RE: PLEASANT VIEW NORTH  
451 VALLEY ROAD  
BUTLER TWP.  
COLUMBIANA COUNTY

**NOTICE OF VIOLATION**

On April 4, 2008, this writer conducted an inspection of the wastewater treatment plant for the Pleasant View North Retirement & Rehabilitation Center. The facility was represented by Mrs. Liz Shutler. The intent of the inspection was to evaluate operations and maintenance of the system. This facility is currently considered to be in significant noncompliance. The following are findings from the inspection.

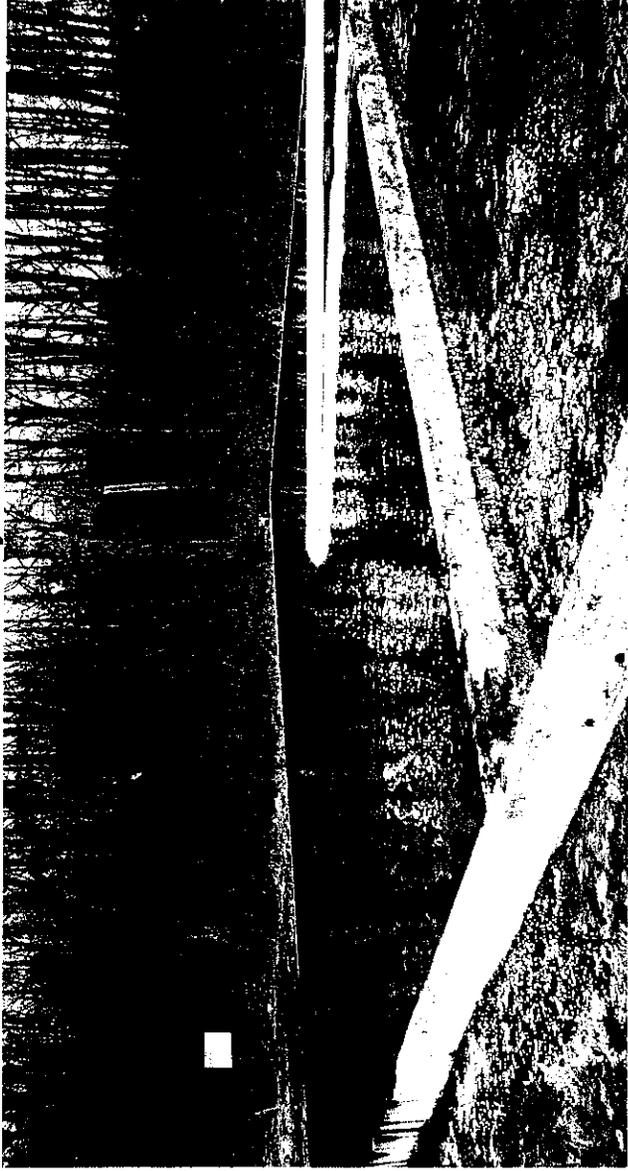
Sand filter is plugged and overflowing. This is an unauthorized discharge of the treatment system.

Filters plugged with solids and need cleaned.
